NOTICE UNDER SCHEDULE VI CHAPTER XI, RULE 2 (I) OF
THE CITY OF KARACHI MUNICIPAL ACT 1933.Karachi 24-6-36.

**KARACHI MUNICIPAL CORPORATION.****BUILDING SECTION.****REVIEW FORM.**

PROPOSED BUILDING ON PLOT NO. 65.

Reference No. B. S. P. 393/36

SITE PLAN.
SCALE 20" = 1" INCH.

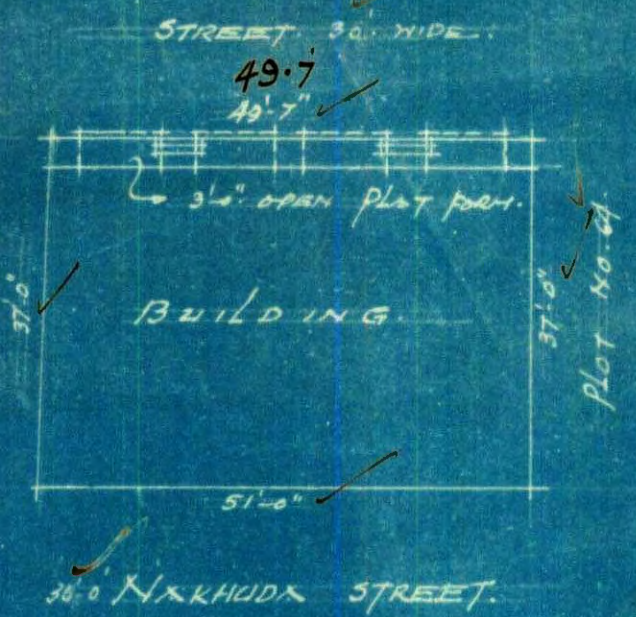
No objection to the site plan.

GROUND FLOOR.

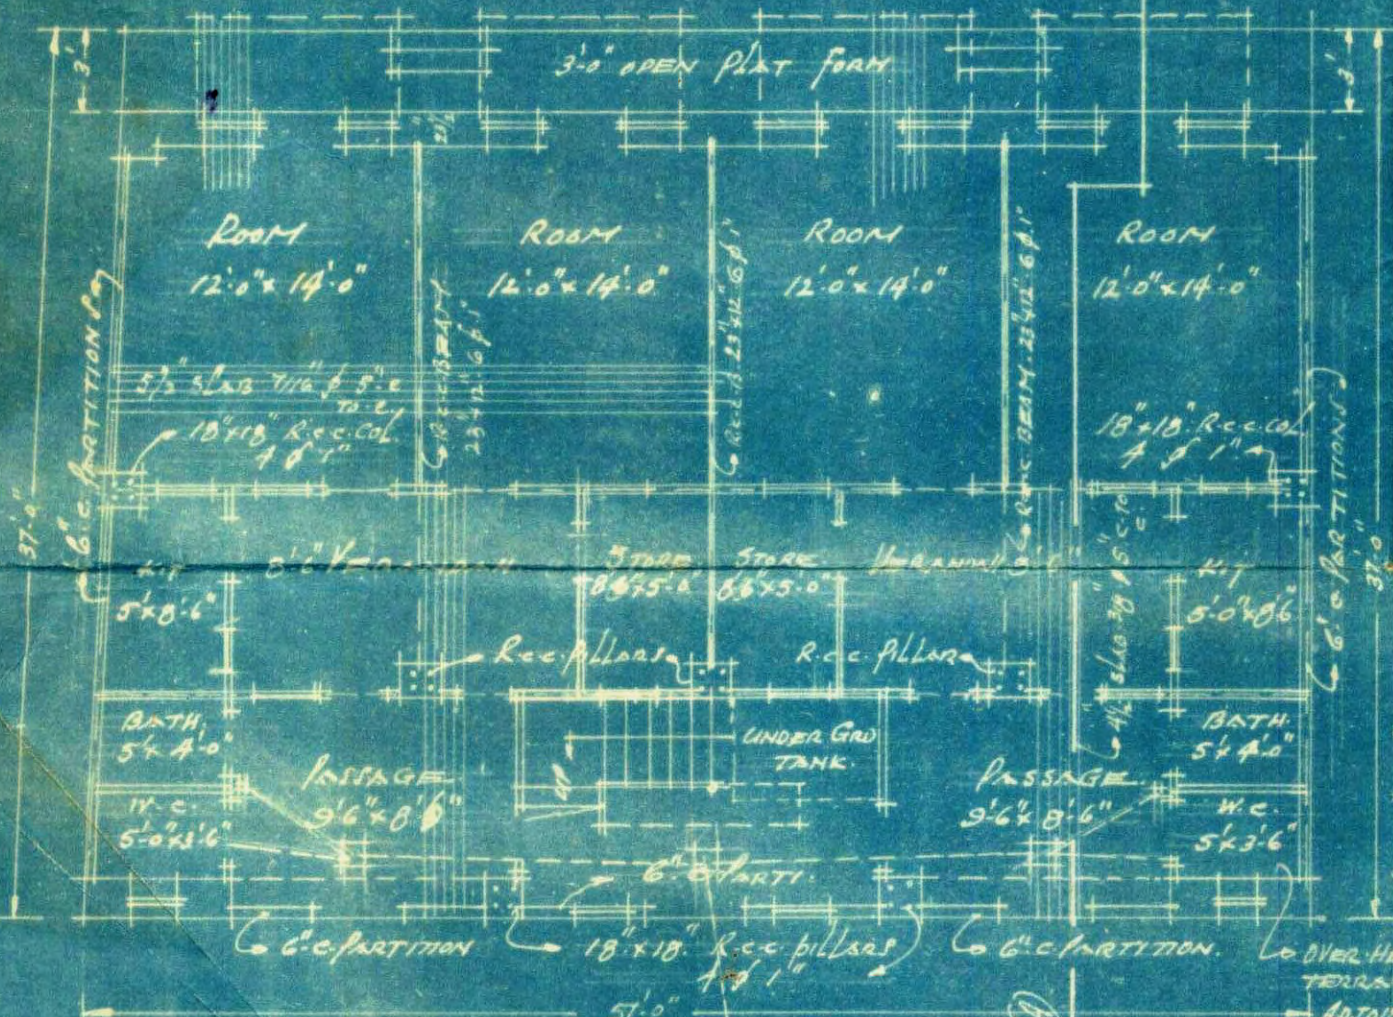
Under ground Tank below staircase is not desirable.

1. Underground tank below staircase is not desirable
2. Soil pipes should abut on external walls.
3. Balconies on the north must be confined to the land set back by the owner.
4. Jafferri not more than 6' must be provided in the front passage as otherwise the verandahs will be dark
5. Wall on the north to be 23½", 23½", 18½" and 18½".

Underground tank is now shifted from below
the staircase (shown in the plan)

FIRST SECOND & THIRD FLOOR.

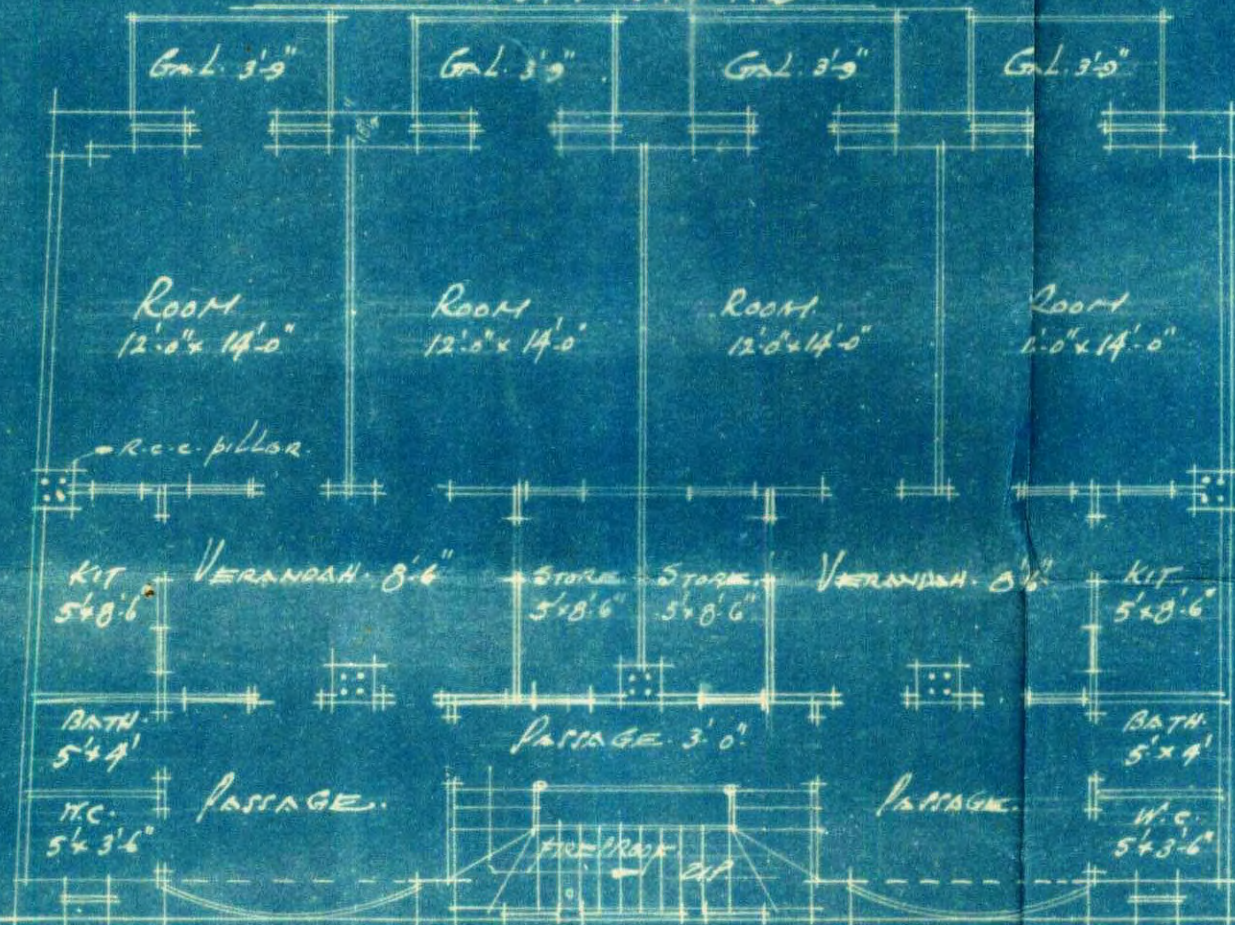
1. Balcony on the north must be confined to the land, set back by the owner.
2. Jaffi not more than 6' must be provided in the front passage as otherwise the verandahs will be dark.
3. Wall on the North to be $23\frac{1}{2}"$, $23\frac{1}{2}"$, $18\frac{1}{2}"$, $18\frac{1}{2}"$.

Complied with.

5' Galleries are only provided.

Thickness of walls shown in the plan
are as per Municipal Bye-law.
